**Re: Fuller Middle School**

*District's Response to the Design Development Review Comments*

City of Framingham  
Fuller Middle School  
Design Development  
MSBA Review Comment Responses  
6/21/19

**APPENDIX 6A**  
**MODULE 6 – DESIGN DEVELOPMENT REVIEW COMMENTS**

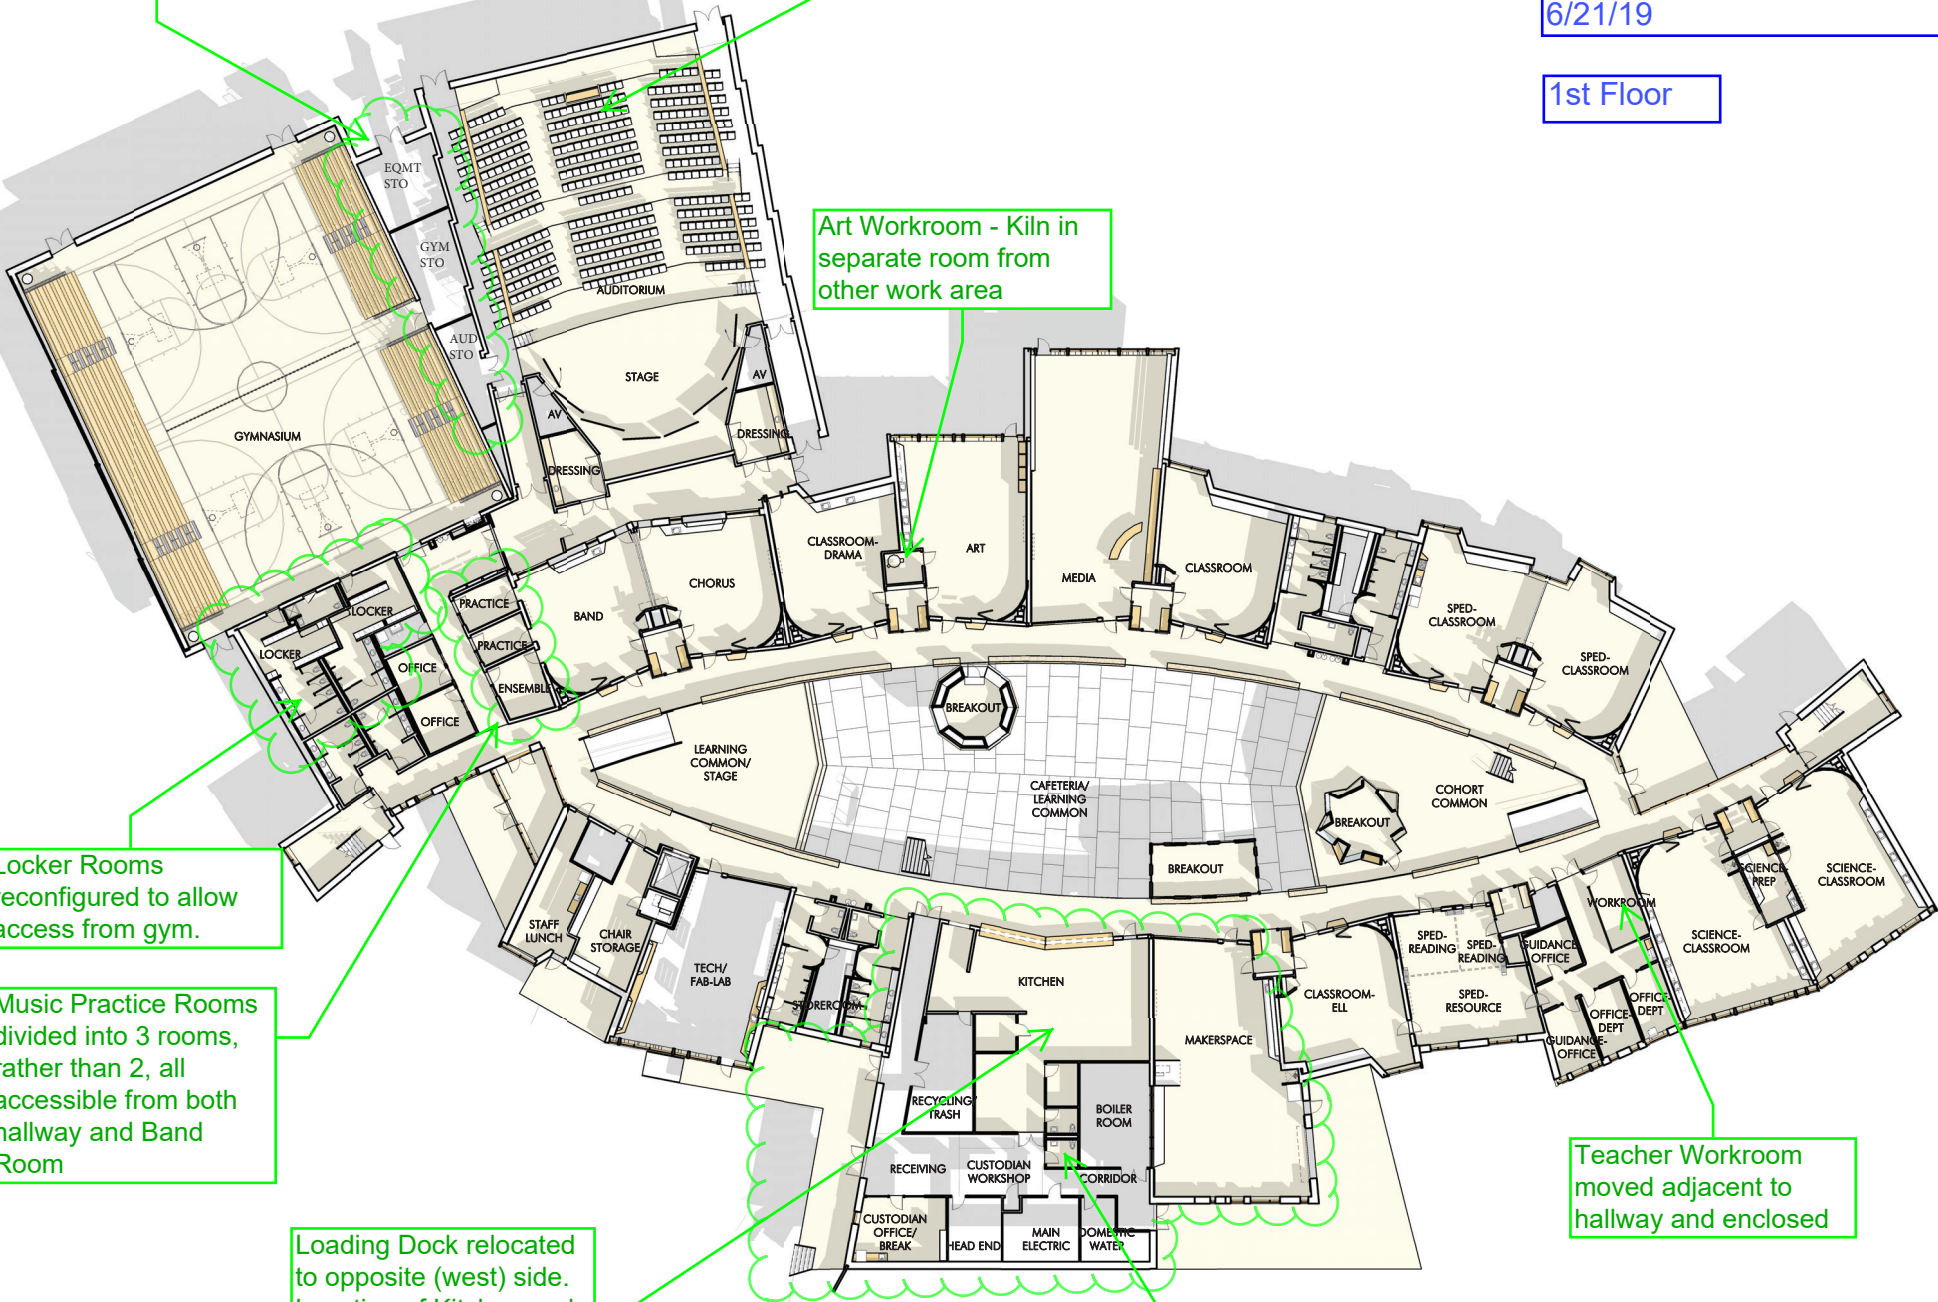
Auditorium rotated 90 degrees

Art Workroom - Kiln in separate room from other work area

Locker Rooms reconfigured to allow access from gym.

Music Practice Rooms divided into 3 rooms, rather than 2, all accessible from both hallway and Band Room

Added staff toilet room

3rd Floor

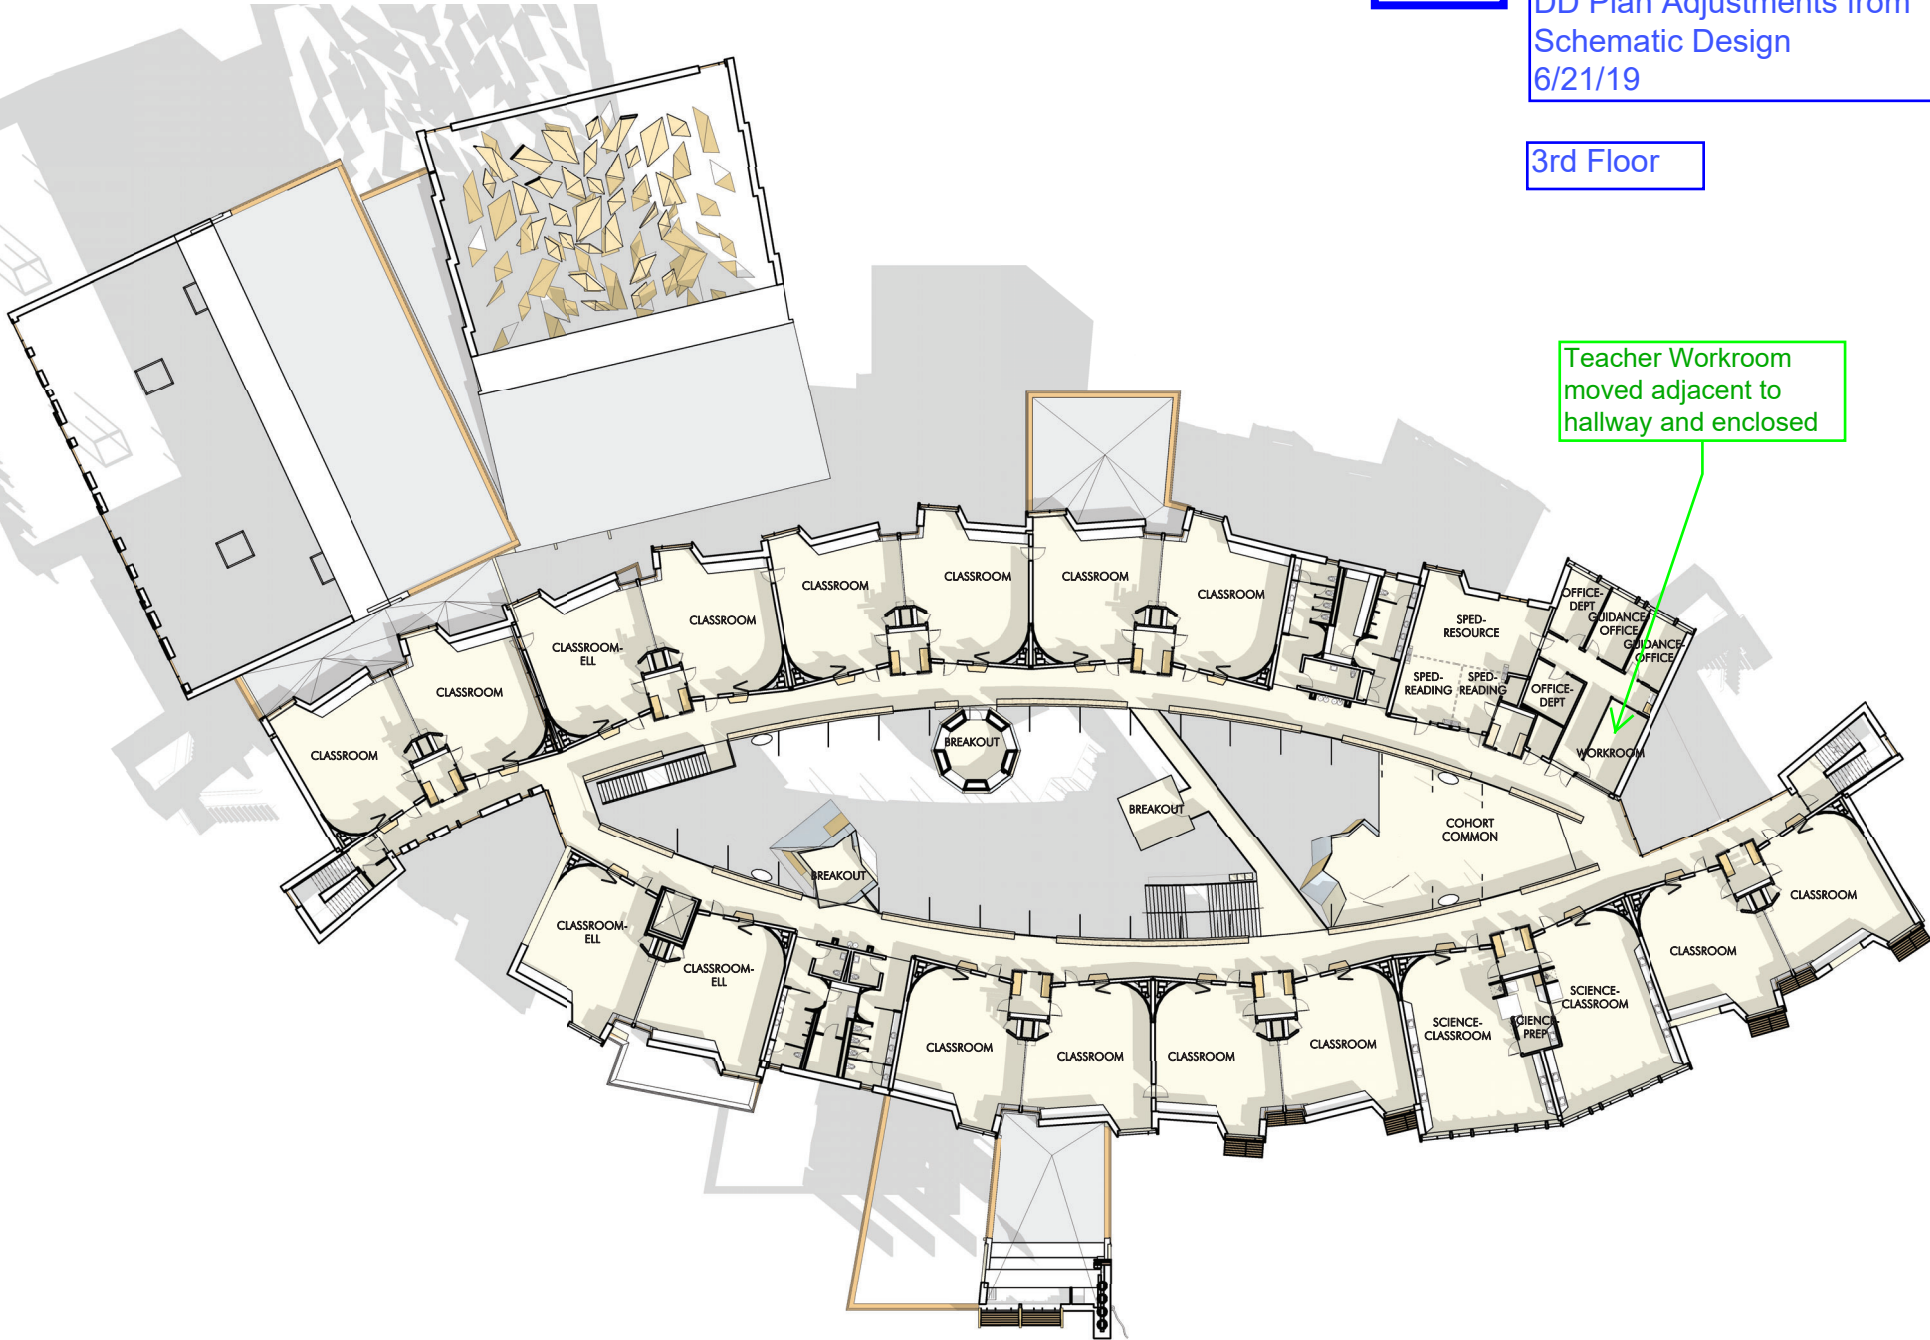
Teacher Workroom  
moved adjacent to  
hallway and enclosed
